~~Draft~~Final Environmental Impact Statement

Volume III of HIV Chapter XI. Parties Consulted During the 45-Day Comment Period on the Draft Environmental Impact Statement; Letters Received and Responses to Substantive Comments (Part II)

PROPOSED OLOWALU TOWN MASTER PLAN (TMK Nos. (2)4-8-003:84, 98 through 118, and 124)

XI. PARTIES CONSULTED DURING THE REVIEW OF THE DRAFT ENVIRONMENTAL IMPACT STATEMENT, LETTERS RECEIVED AND RESPONSES TO SUBSTANTIVE COMMENT LETTERS

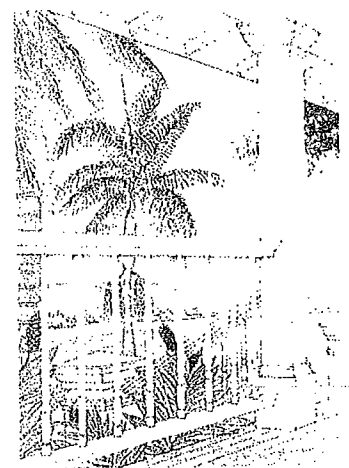
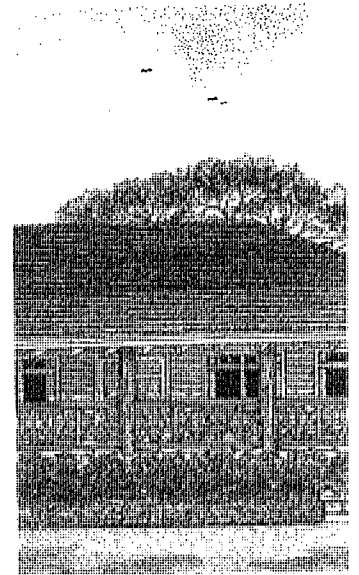
Another prime example of this developers deceit is in the enclosed excerpt from the sales and marketing brochure presented to prospective buyers of Olowalu Mauka at the inception. If you look at the rendering enclosed, you will see absolutely no resemblance to what exists today ... Our HOA had to fight with them just to remove the cattle gate that was there ... Another example, quoted in their brochure "Canopies of mature trees." We were to receive over 200 trees planted and that never happened. Total misrepresentations The residents here in Olowalu Mauka have been victims for much too long of these developers empty promises and deceitful ways, it just goes on and on. The same will happen if they are allowed to proceed with this proposed development. A precious commodity, treasured by so many, will be inevitably destroyed. PLEASE don't let them get away with this any longer, Enough is Enough.

distinct from Olowalu Elua Associates, LLC, developer of the 14-lot Olowalu Mauka Subdivision. We do understand however, that the phased landscaping plan has been planted in the 14-lot Olowalu Mauka Subdivision and the Planning Department has confirmed all conditions of the SMA Permit, including the phased landscape plan have been met by Olowalu Elua Associates, LLC. The OTMP proposes a network of greenways that will connect to the existing greenways in the Olowalu Mauka Subdivision which will eventually provide a buffer between the OTMP and Olowalu Mauka Subdivision, as well as connect the Olowalu Mauka Subdivision to commercial/office, public/quasi-public and recreational uses in the OTMP.

Figure 4

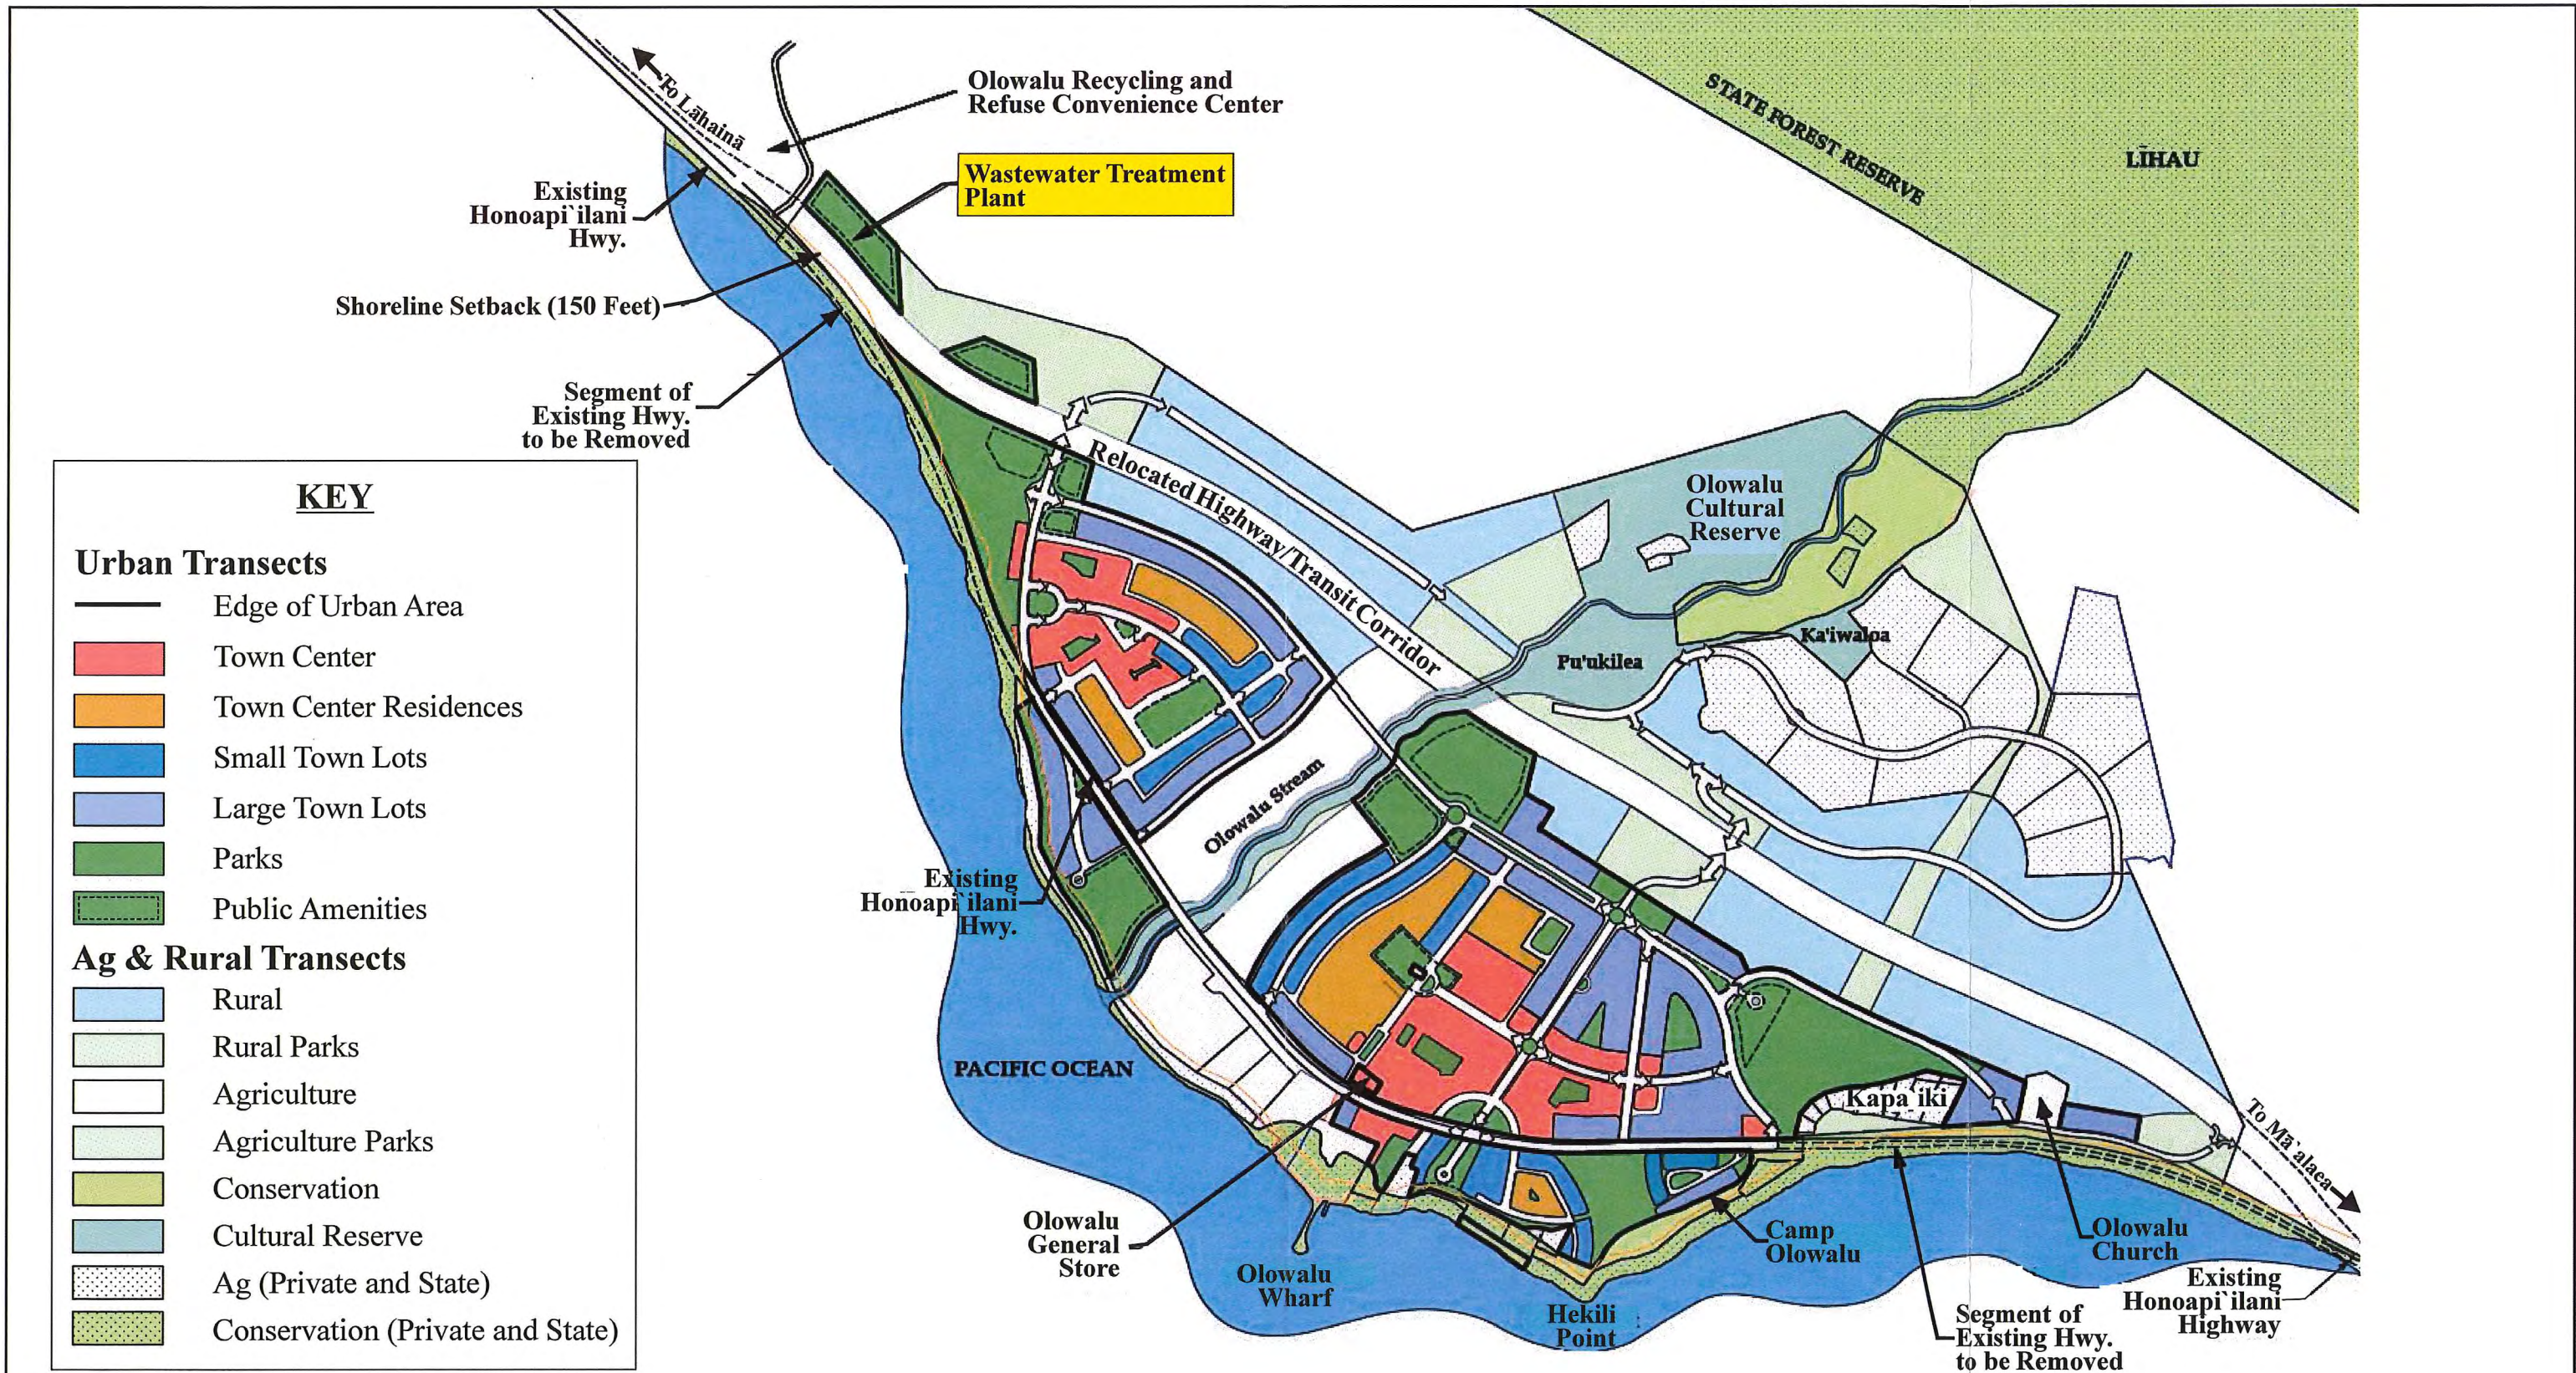
P.S. Where is their proposed sewage treatment plan to be located? I certainly hope that issue is brought to the forefront before we end up with another situation such as Kaanapali with the stench.

The proposed wastewater treatment facility will be located at the western extent of the Proposed OTMP, mauka of Honoapiilani Highway. See **Exhibit "1"**, Conceptual Plan, which was provided in the Draft EIS as Figure 4. For your ease of reference, however, we have highlighted the location of the wastewater treatment facility.
